Design Development Summary of Pre-Application Report

The Pre-Planning Application was submitted on 11th July 2018 and a site meeting was held on 25th July 2018. Following the revised drawings submission, a pre-application meeting was held at Camden Council on 3rd September 2018 and the pre-application report was received on 6th September 2018. In general the Council's advice was positive.

Proposed Ground Floor Plan

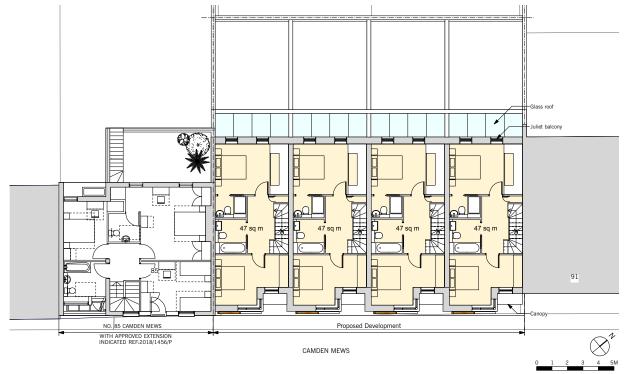
- Transport While sufficient cycle stores are provided, it is recommended to relocate the cycle storage units so thay are near the front doors.
- Construction management Camden Mews has been designated by the Council as a CMP Priority Area, with all developments requiring the submission of a draft CMP upon application and the agreement with the council of a full CMP prior to commencement of works.

- Relocating the cycle storage spaces closer to the front doors
- Omitting Corten cladding at front elevation and replacing with facing brickwork
- Changing the material of the canopy from Corten to powder coated aluminium
- Omitting sliding slatted hard wood screens on the second floor to the front
- Introducing vertical slots in facing brickwork to the rear elevation to articulate the development as four separate houses
- Indicating the appoved developments/extensions to the neighbouring buildings

Proposed Rear Elevation

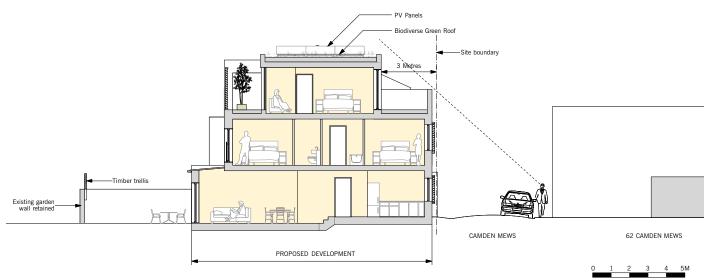
- Detail design: The currently proposed design details make good contextual reference to the Grade II* No. 62 opposite, and are generally welcomed. However, some aspects of the proposal would need to be simplified in order for this to be a solid and coherent addition which either maintains or enhances the character and appearance of the mews. The rear elevation, while acceptable in massing, would require additional detailing on the first and second storeys to subtly but clearly articulate the building as four separate dwellings.

A vertical recess has been introduced to the first floor to clearly articulate the building into four distict buildings.
